**FIELD SERVICE BULLETIN**

FSB Number: LVCCFSB2005-130  
Author: Rajesh Verma  
Date: April 20, 2005  
Total No. of Pages: 3  
Subject: GSM C115 Power Down When Pressing Navigation Keys  
Model Affected: C115/116  
Level of Repair: 2, 3, 4

Fig: 1

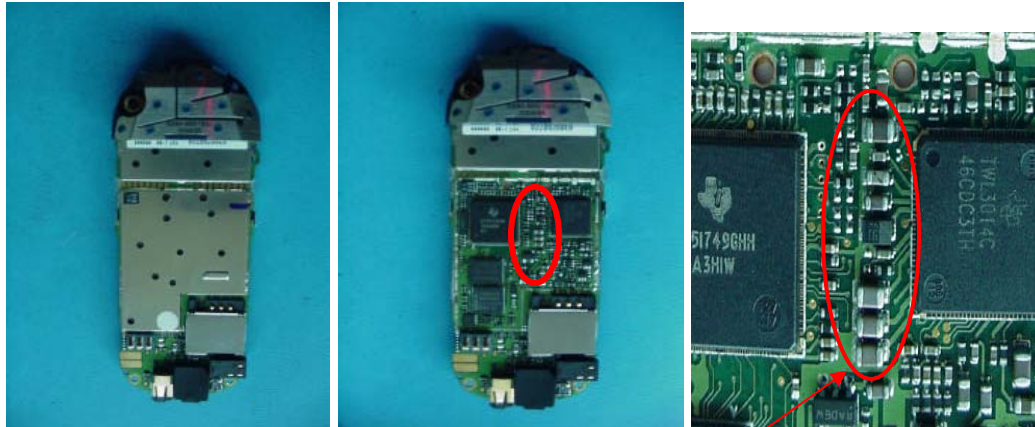
Service is aware of an issue, identified from the field, on GSM C115/116. Some units returned with a customer complaint of “Power down” when the Navigation keys and display bezel is pressed simultaneously as shown in Fig 1 below. Capacitors on the PCB can short the RF shield when this occurs. These capacitors are identified in Figure 2. Customer will have to remove then reinsert the battery again to turn the unit back on.

1. Press the Navigation keys and display bezel as shown in Fig 1 above to verify the customer complaint.
2. If unit powers down, remove and reinsert the battery to turn the unit back on
  - a) If unit turn on, remove the RF shield and place a Kapton tape as insulator as shown in Fig: 3 above.
3. Reassemble, and then Retest the unit per the Customer Complaint to verify unit is repaired and does not exhibit failure symptoms.
  - a) If unit is not repaired by the insulating process, then proceed with normal troubleshooting techniques as per the customer complaint.

Fig: 2

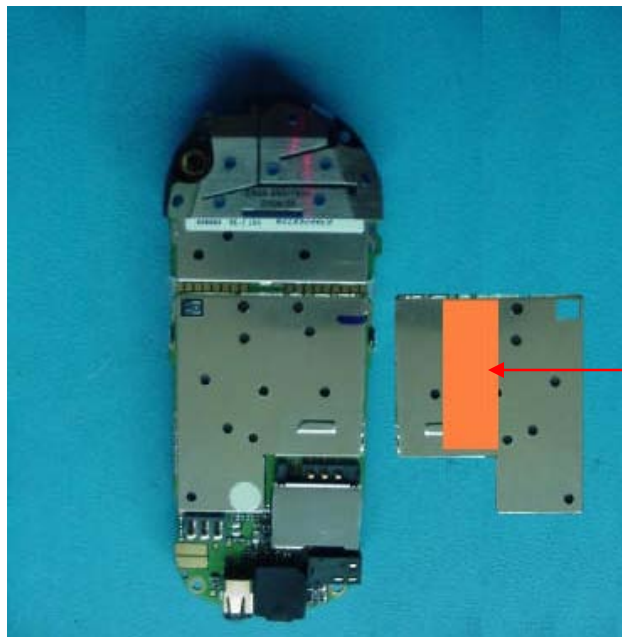
These capacitors may short to shield when Navigation keys are pressed.

Factory implemented a Work Instruction to place a Kapton tape on the RF shield above the capacitors to act as an insulator. See Fig 3.0 below where Kapton tape is placed.

Apply Kapton Tape here as Insulator
